Staff Report

SITE PLAN REVIEW APPLICATION – TYPE I-L

NWN ALBANY SERVICE YARD EXPANSION

WATER AND WASTEWATER PLAN C1

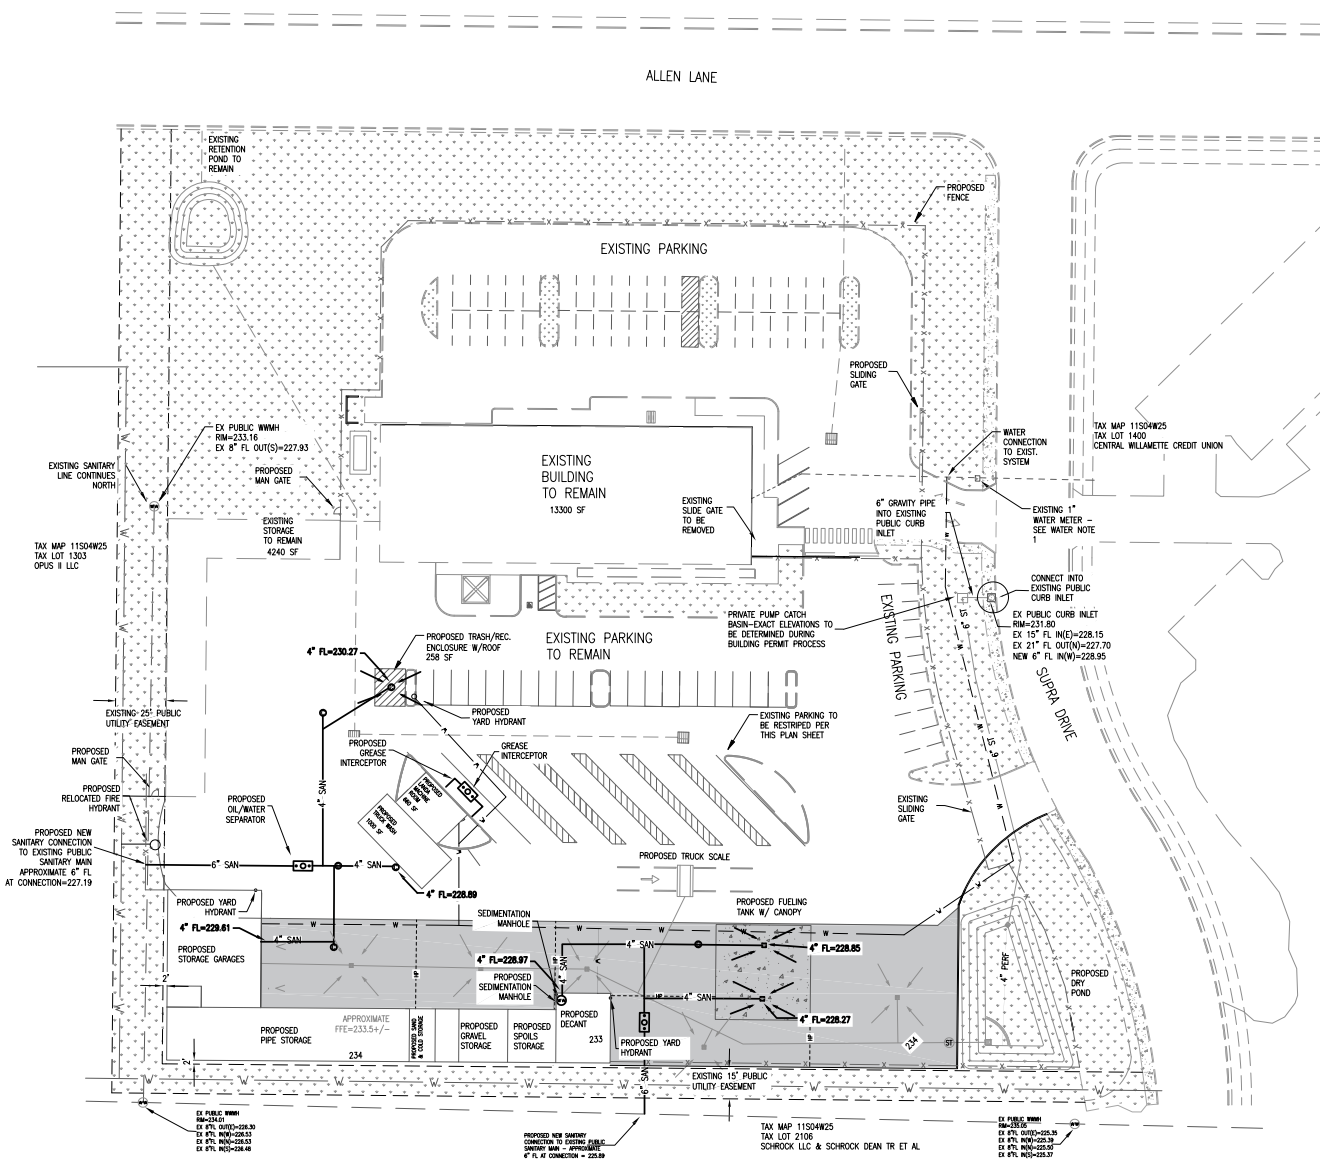
7.2: The applicant’s preliminary site plan indicates that the proposed development will be connected to a new private sewer lateral from the sanitary sewer main to the west. The preliminary site plans show a fueling station with sewer catch basins and sewer catch basin for a truck wash station. The proposed development shows a “Decant Building” for disposal of wet material from vacuum truck operations. The Decant Building has a sanitary sewer inlet from this building that discharges to the sanitary sewer system. AMC 10.01.040 regulates discharge into the public sanitary sewer system. The sewer catch basins/inlets shall be covered and graded to prevent rain runoff from entering the sanitary sewer system. The sanitary sewer catch basins/inlets shall flow through an oil/water separator prior to entering the public sanitary sewer system. The Decant Building inlet shall have sediment removal Best Management Practices installed prior to discharge to public sanitary sewer systems. Best Management Practices shall be reviewed and approved by City of Albany’s Engineering Division prior to installation.

7.4: The applicant’s preliminary utility plan indicates that the proposed development will connect to the existing water service serving the site. The preliminary utility plan indicates the relocation of a public fire hydrant. The developer must obtain a Permit for Private Construction of Public Improvements through the City of Albany’s Engineering Division.

STORM AND GRADING PLAN C2

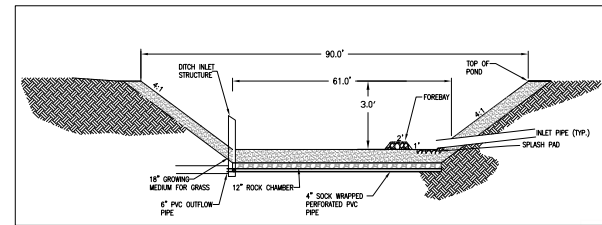
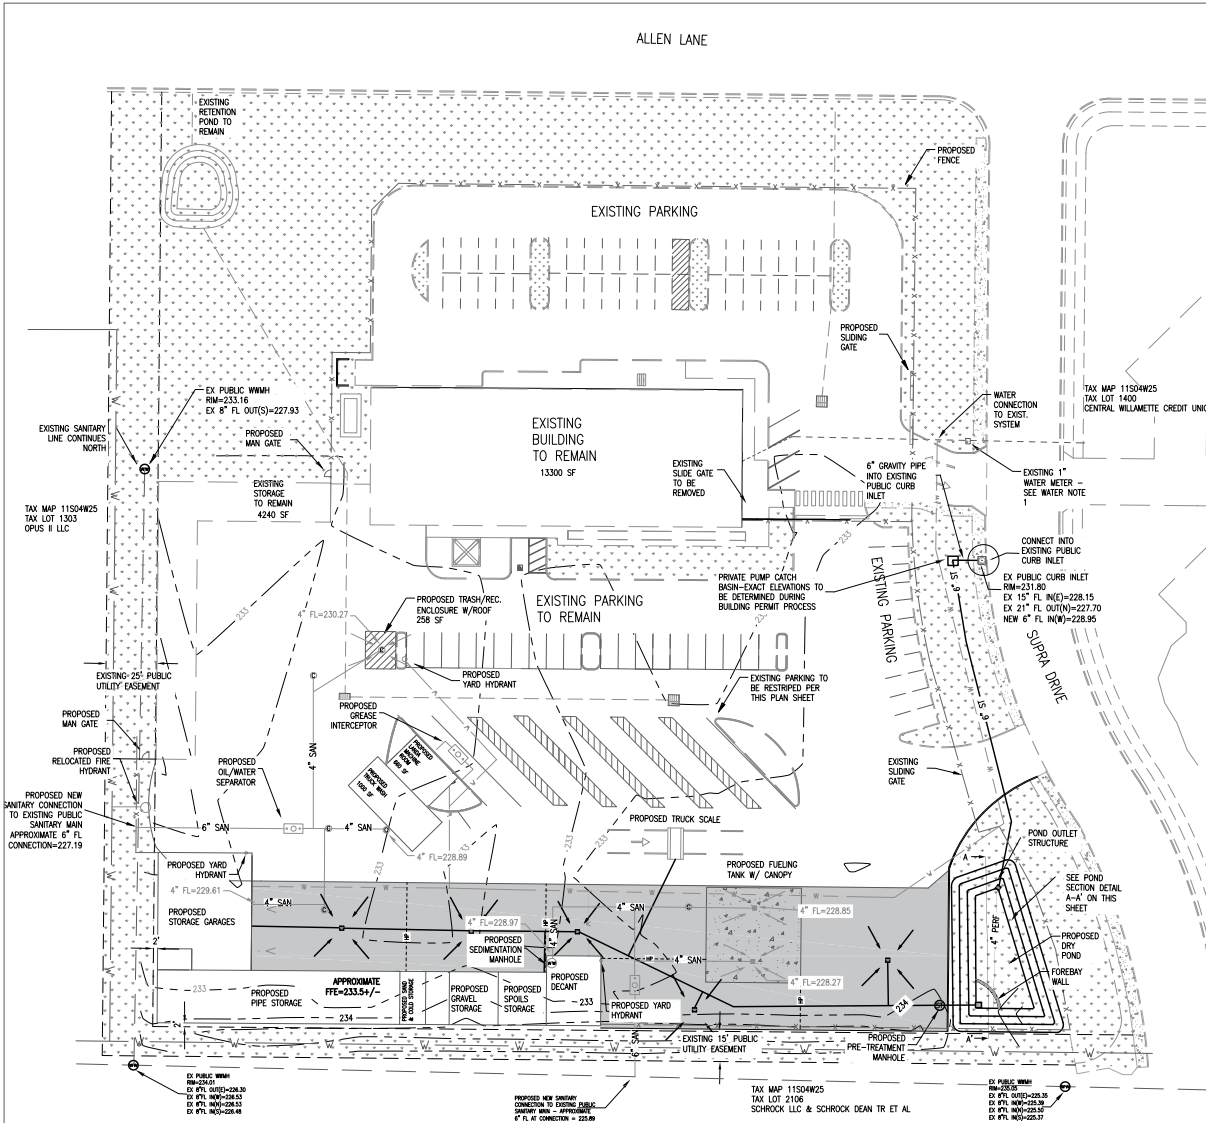
- 7.5: The applicant shall construct stormwater detention facilities to provide storm and flood-water controls. Before the City will issue any occupancy permit for the proposed project, the applicant must construct stormwater detention facilities that comply with the City's Engineering Standards.

- 7.6: The applicant must provide detention and stormwater quality facilities for the proposed development.
